August 5, 2014

RE: Proposed BURNCO Aggregate Project Update

Summary of Project Refinements

FIGURE 2

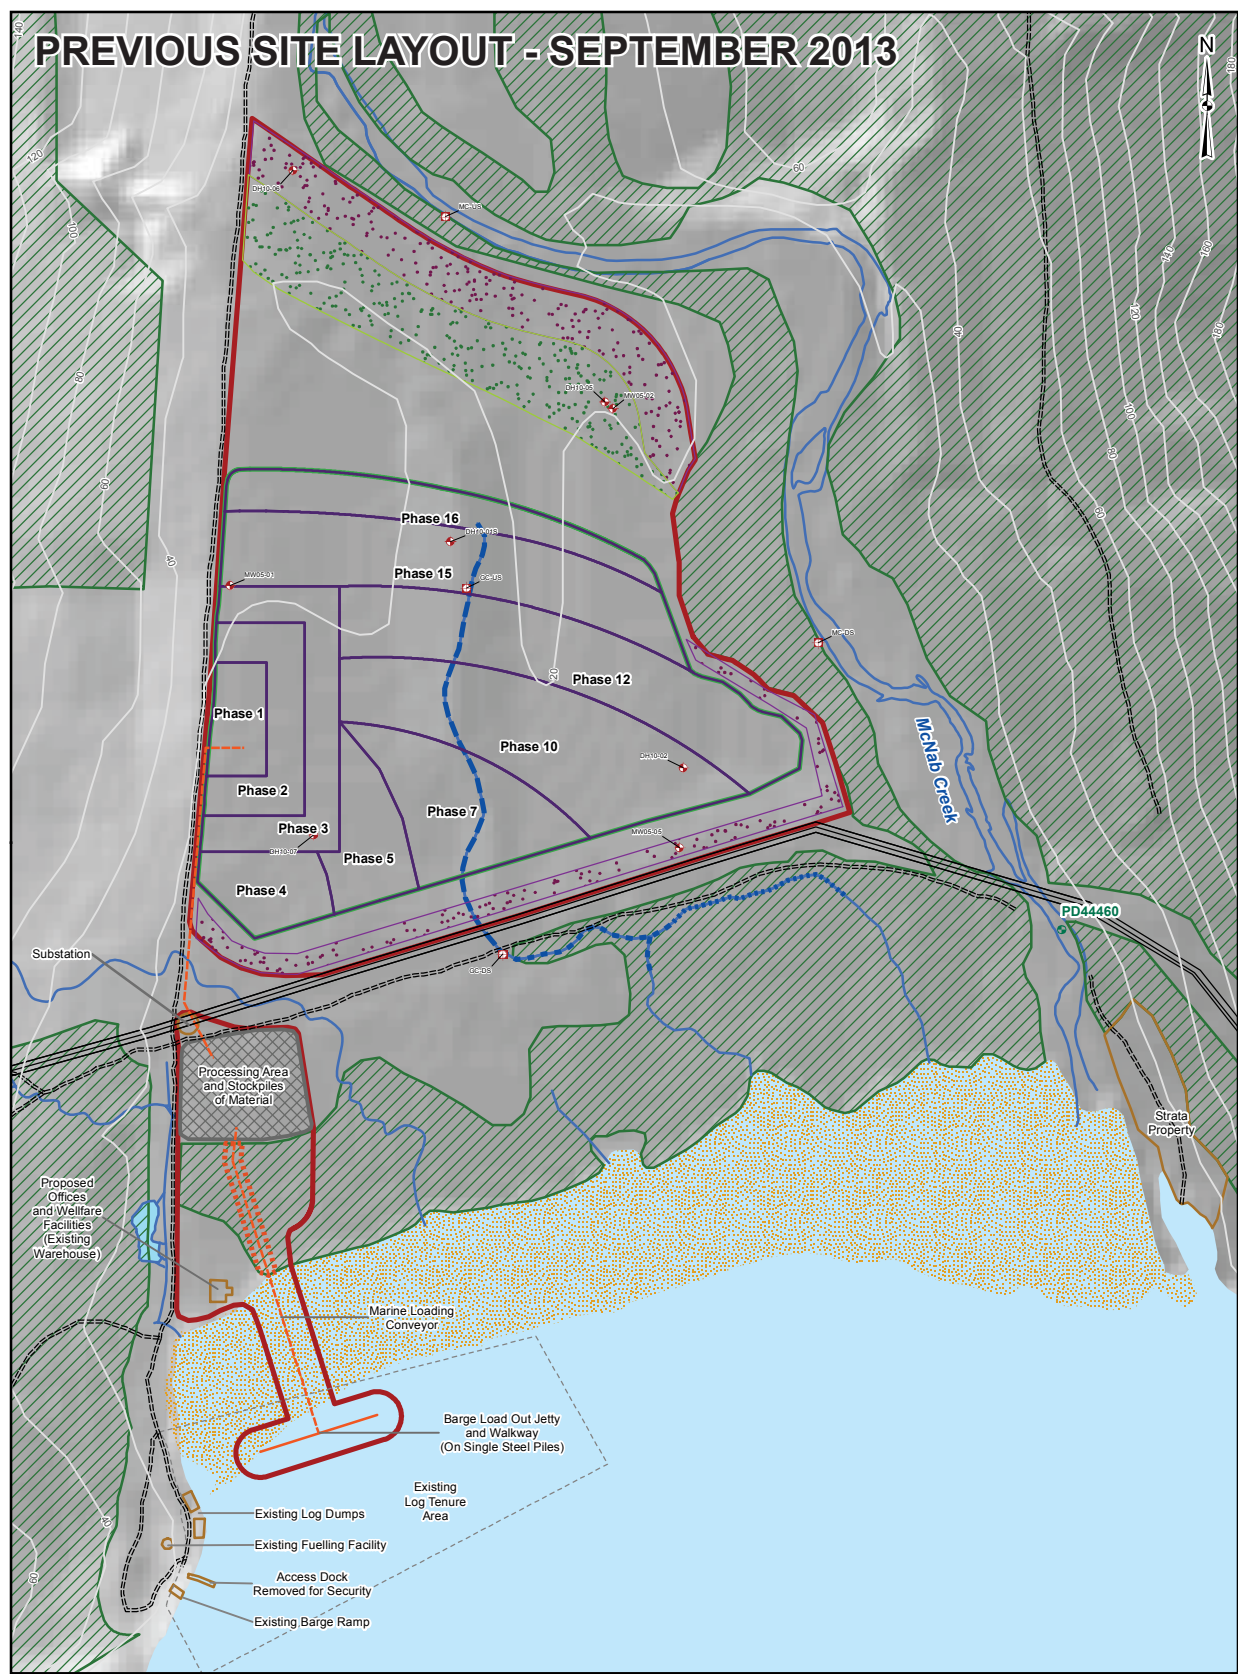
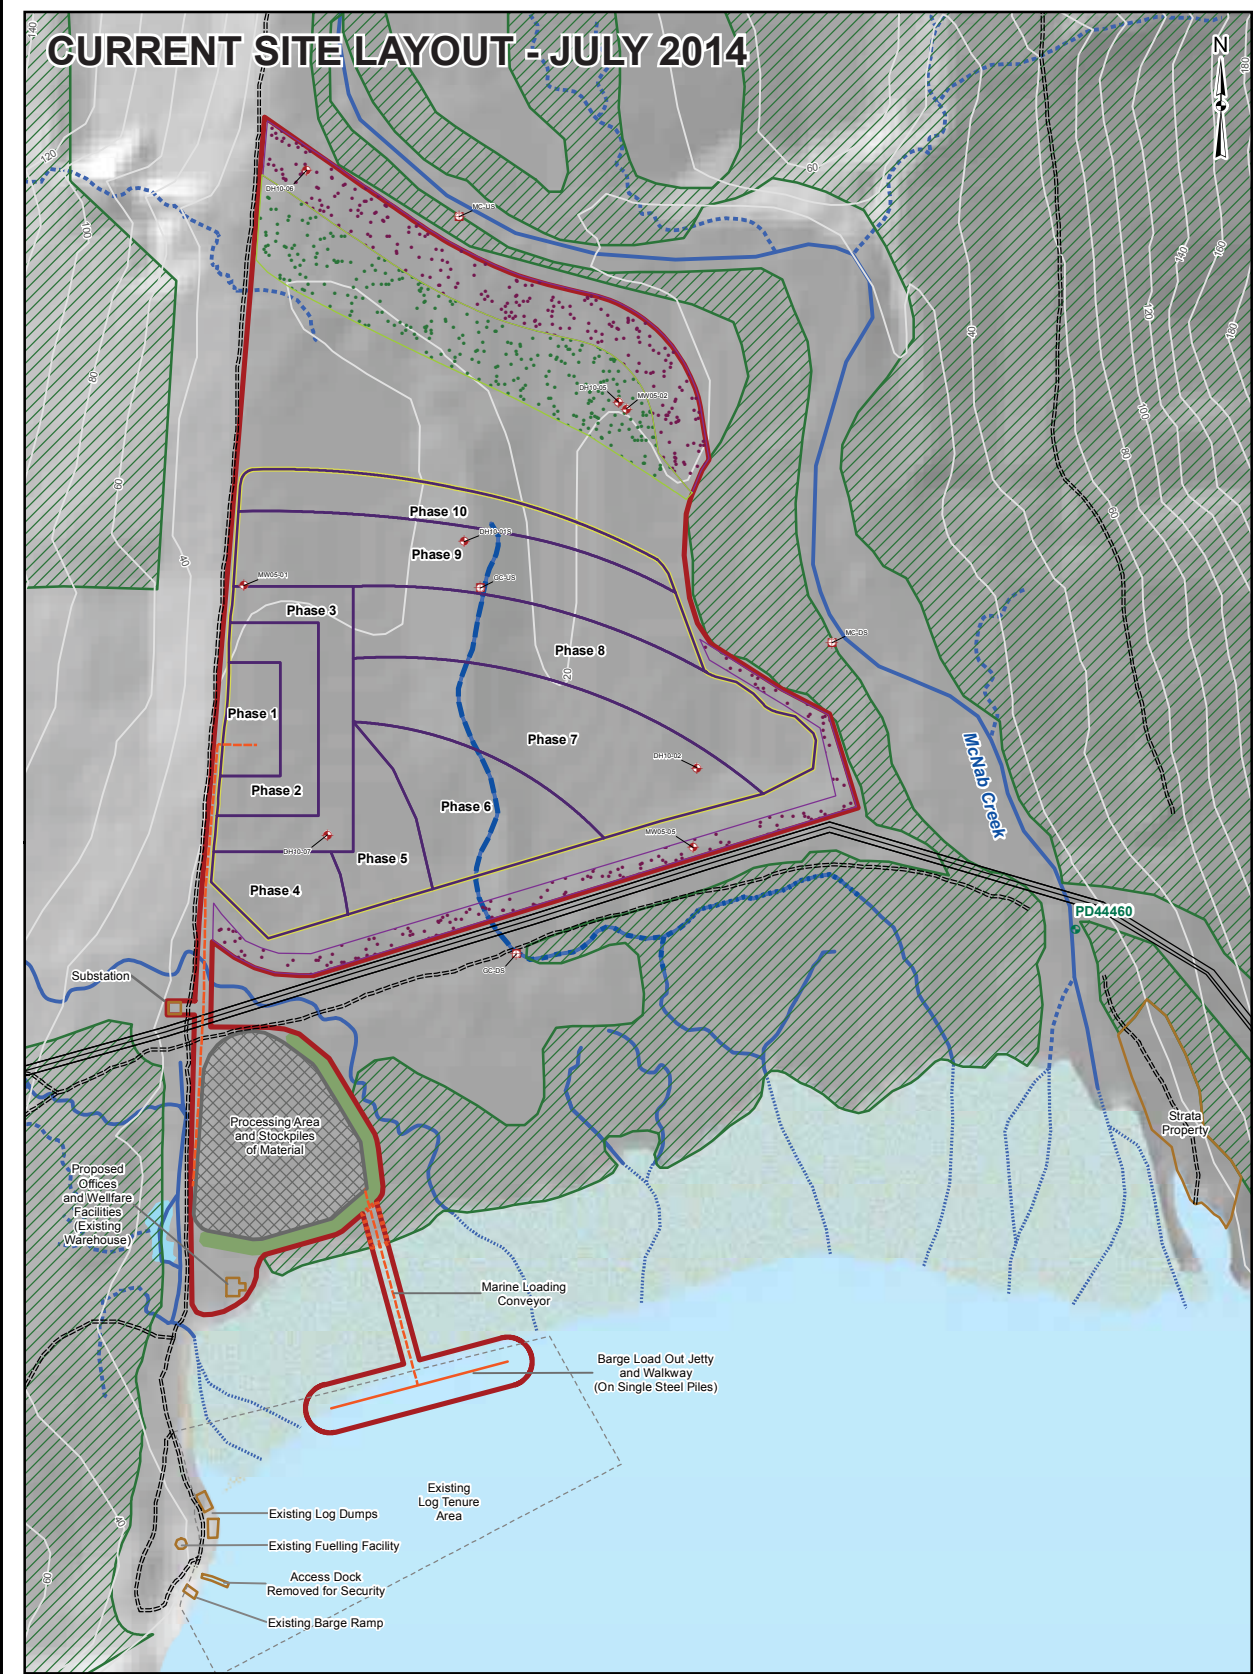
In early 2014, BURNCO commissioned a process engineering firm to prepare detailed design drawings of the proposed aggregate processing area, including the screens and crusher, the wash plant, stockpiles and all associated tunnels and above ground conveyor for moving aggregate to, from and around the site. In preparing the detailed design, it was determined that the size of the processing area needed to accommodate the required network of conveyors was larger than previously proposed. In redesigning the processing area, BURNCO considered the proximity of the site to the McNab Strata Residences and identified fish habitat. The maintenance of a treed buffer along the foreshore was also a key consideration.

The re-orientation of the processing area also required relocating the marine loading conveyor to exit from the south-east corner of the site, approximately 125 m east of where it had been previously proposed. This change was made to accommodate process design requirements, as well as to enable the barge load out jetty to be located perpendicular to shore in water deep enough to accommodate 5,500 DWT barges.

A summary of these revisions is presented in Table 1 below. Side-by-side comparisons of the September 2013 and July 2014 processing area and marine loading concepts are attached. All existing baseline information has been reviewed to confirm that there is sufficient information upon which to base an assessment of the revised processing area size and orientation. In light of these refinements, potential air quality, noise and visual quality effects of the proposed Project have been re-modelled. The EA is being conducted based on the new processing area size and orientation and the new marine loading conveyor location.
